**Town of Surfside  
PLANNING & ZONING BOARD  
AGENDA**

**January 28, 2021 – 6:00 p.m.**

**To:** Planning and Zoning Board  
**Thru:** Andrew Hyatt, Town Manager  
**From:** Walter Keller, PE, AICP., Town Consultant Planner  
Marlin Engineering, Inc.  
**CC:** Jason Greene, Assistant Town Manager  
Lillian Arango, Town Attorney  
**Date:** January 18, 2021  
**RE:** **924 88<sup>th</sup> Street – New Single-Family U/C 2<sup>nd</sup> Floor Modification**

**To:** Planning and Zoning Board  
**Thru:** Andrew Hyatt, Town Manager  
**From:** Walter Keller, PE, AICP., Town Consultant Planner  
Marlin Engineering, Inc.  
**CC:** Jason Greene, Assistant Town Manager  
Lillian Arango, Town Attorney  
**Date** January 18, 2021  
**RE:** 8835 Garland Avenue – Garage Conversion and Driveway/Hardscape Revisions

# Exhibit 4 - Previously Approved Arrangement of Average Setbacks

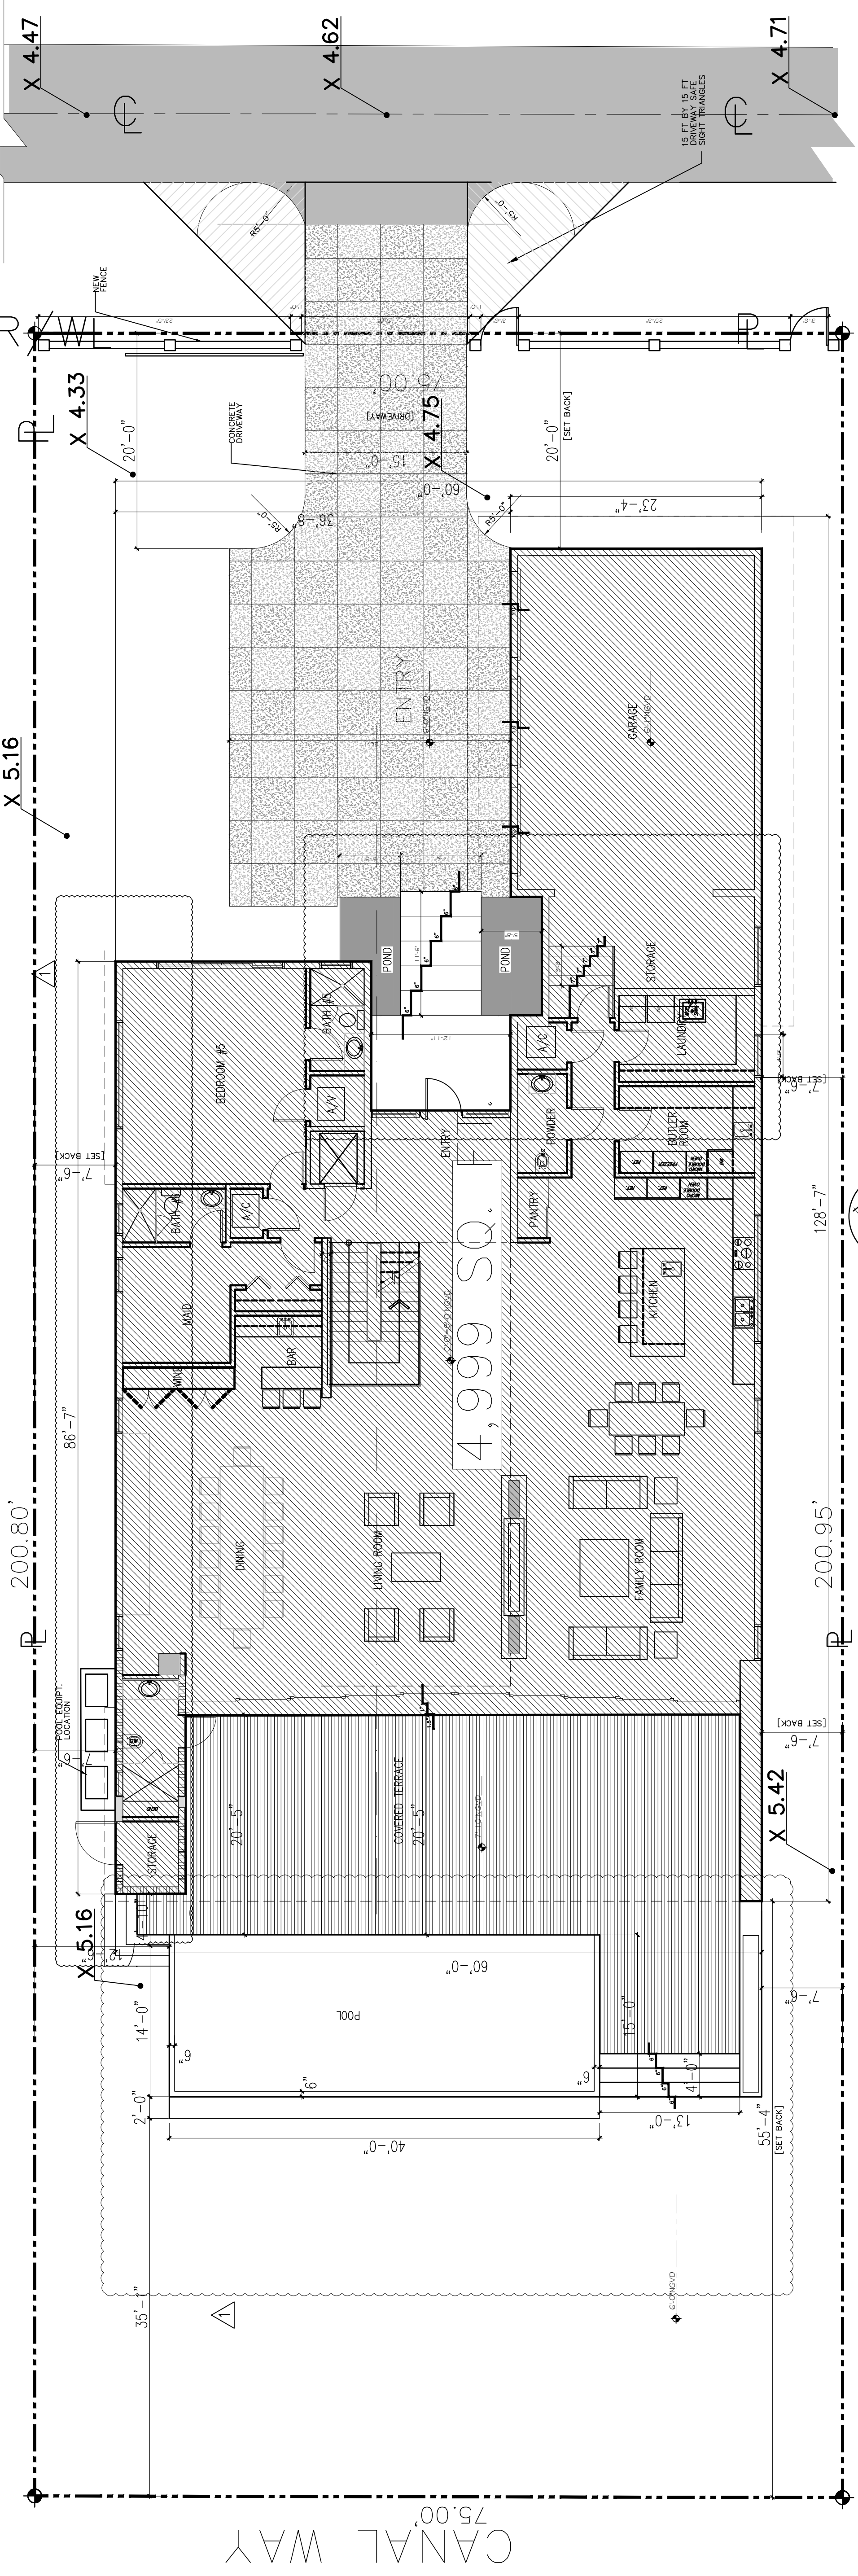
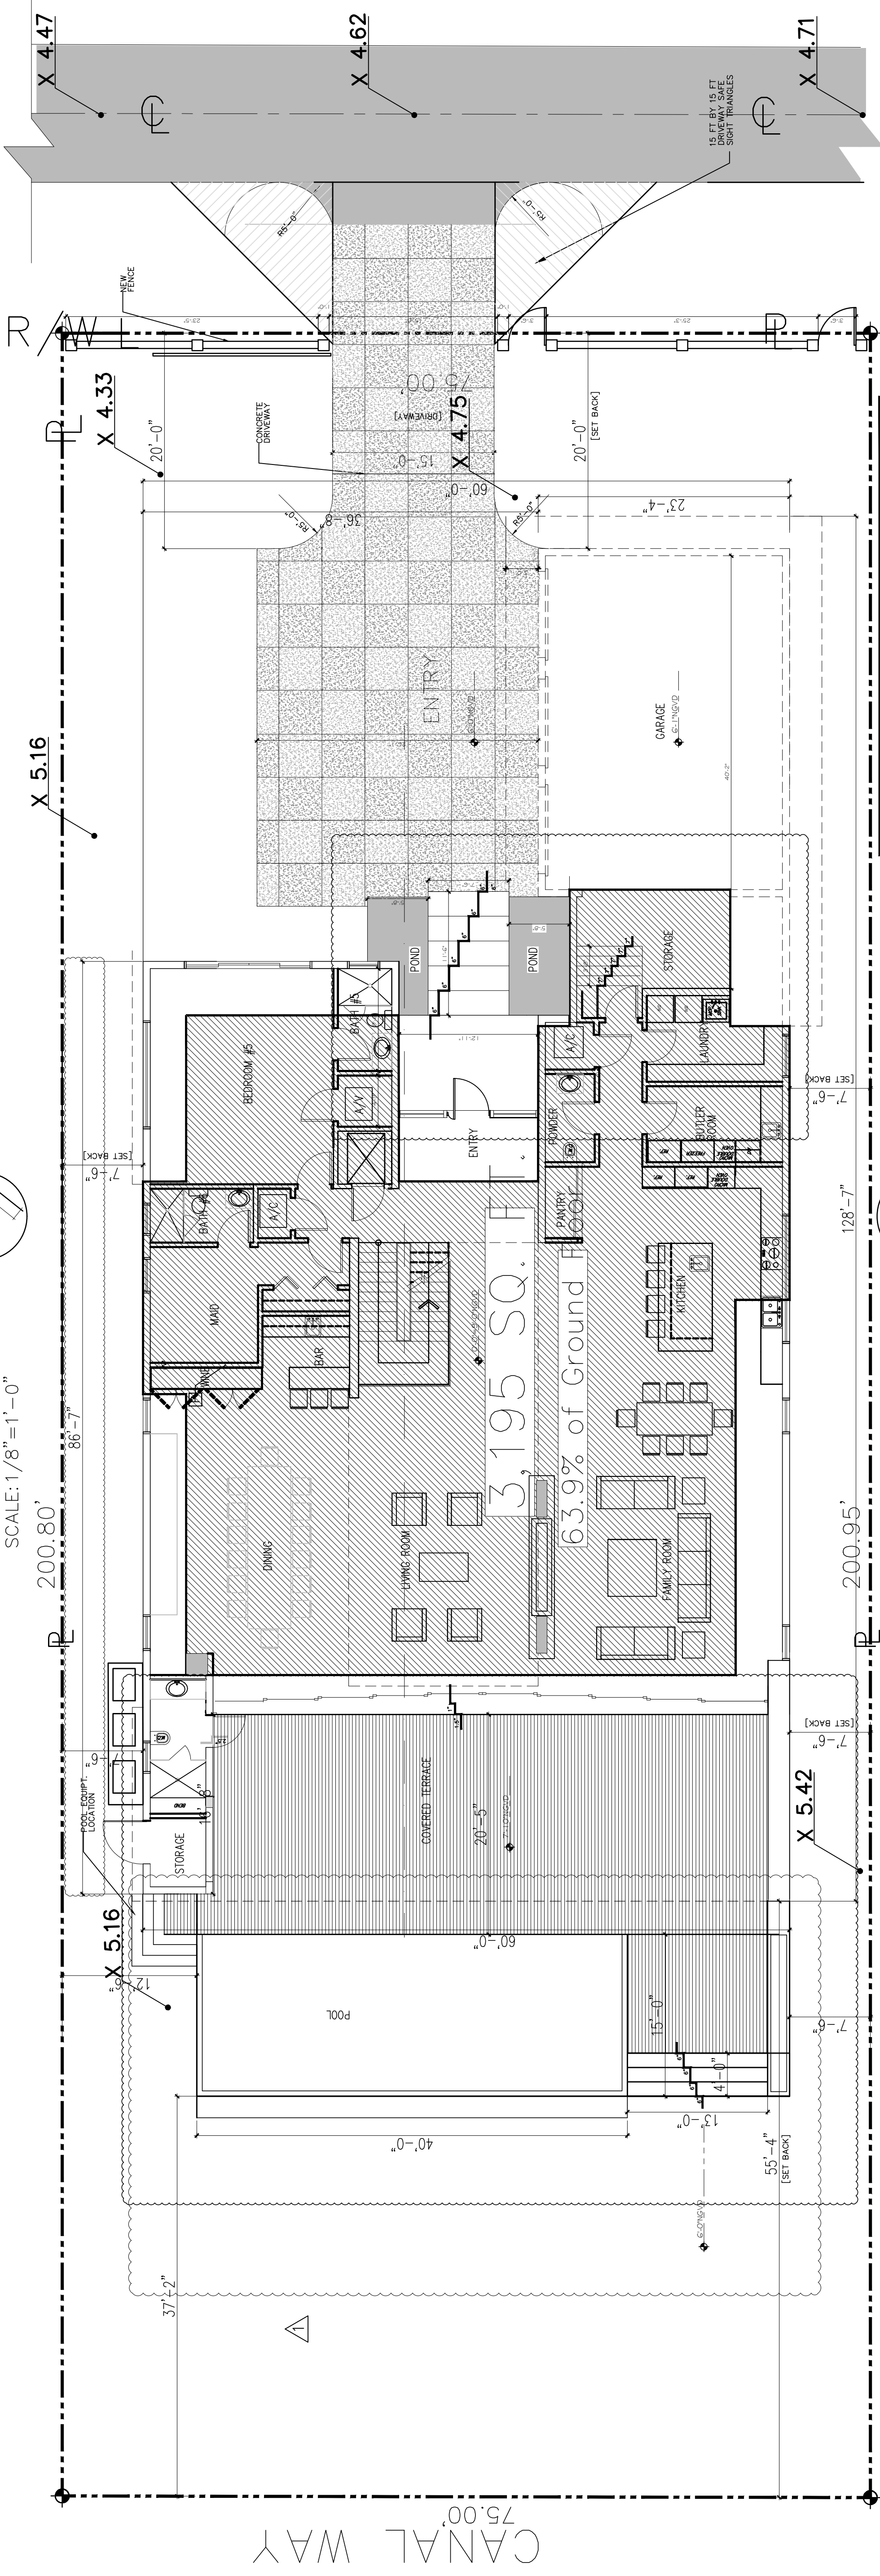
The Planning and Zoning Board approved the two-story single family site plan in January 2017. The approved 2<sup>nd</sup> floor area included 4 building wall cut-outs, two on each side. A site plan modification is requested to remove the cut-outs and manage the average side setback area by utilizing areas where the second floor is set farther back from the front property line. While the second floor square footage will increase, the second floor is 70.5 % of the ground floor square footage.

**PROPOSED SECOND FLOOR SITE PLAN**

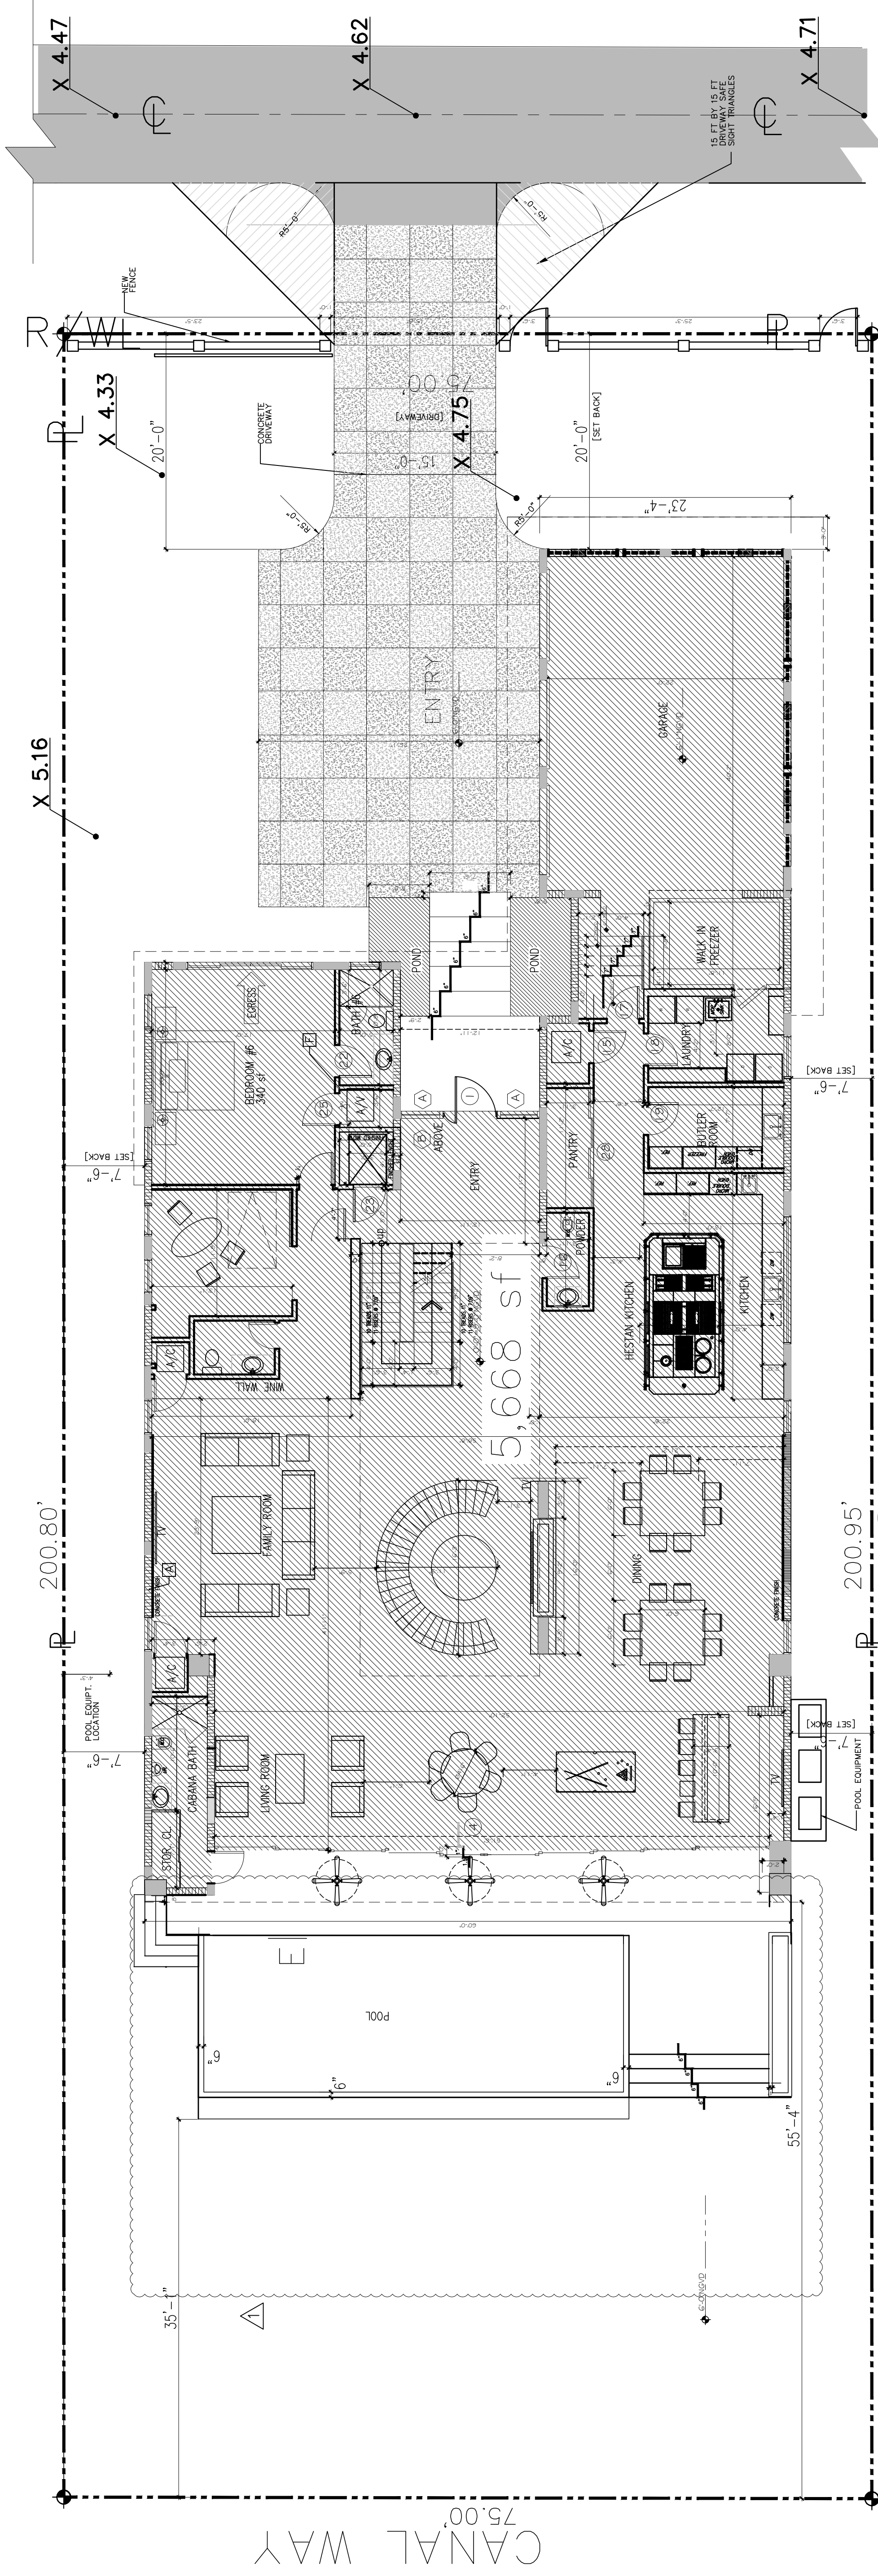
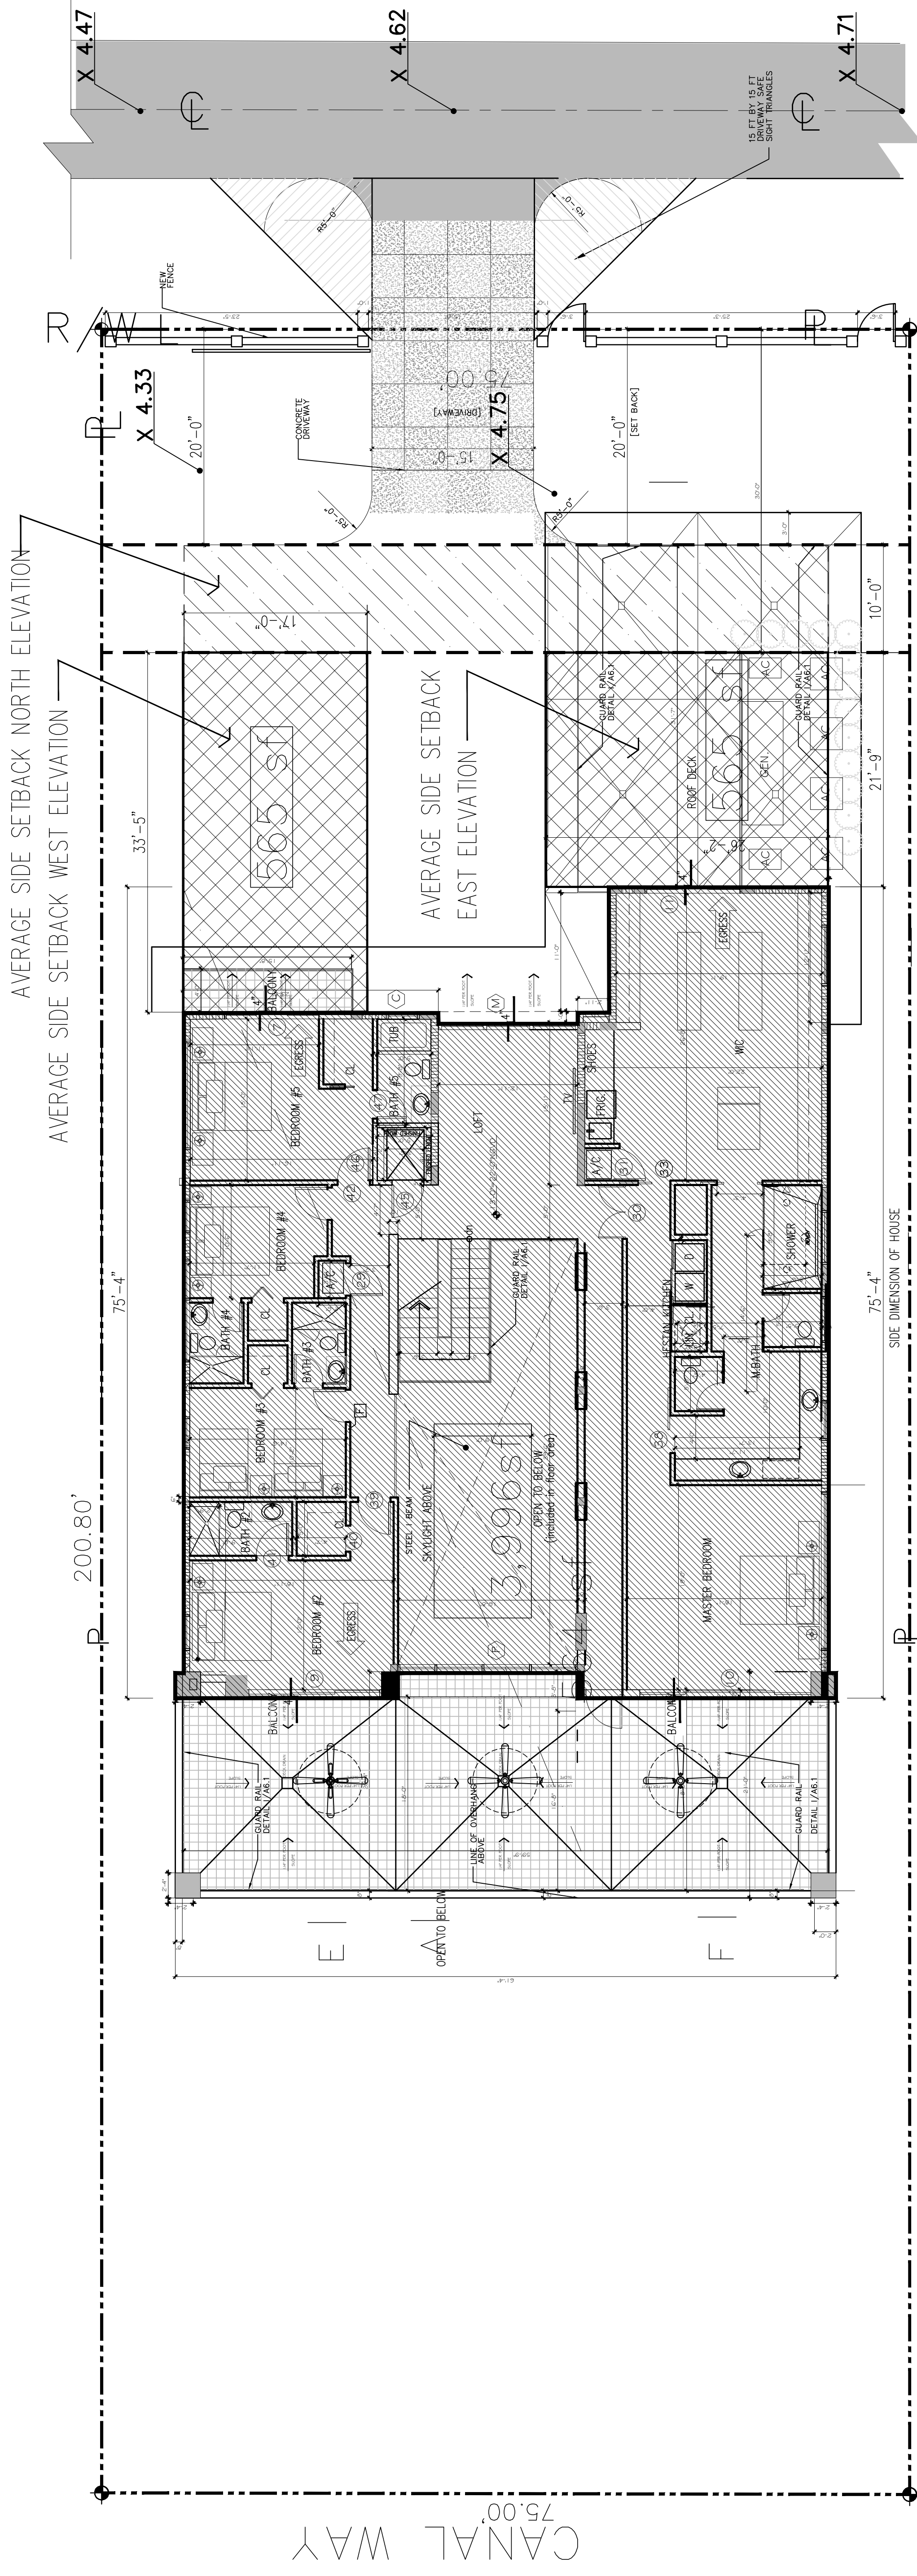
**Background:** This application is a request to modify a previously approved single family site plan which is under construction. The parcel is located in the H30A Zoning District with a lot area of 15.570 square feet. In addition to this Memorandum, four exhibits submitted by the Applicant are attached.

**Staff Recommendation:** The Applicant's proposed 2<sup>nd</sup> floor wall modification is consistent with the Code and should be approved.
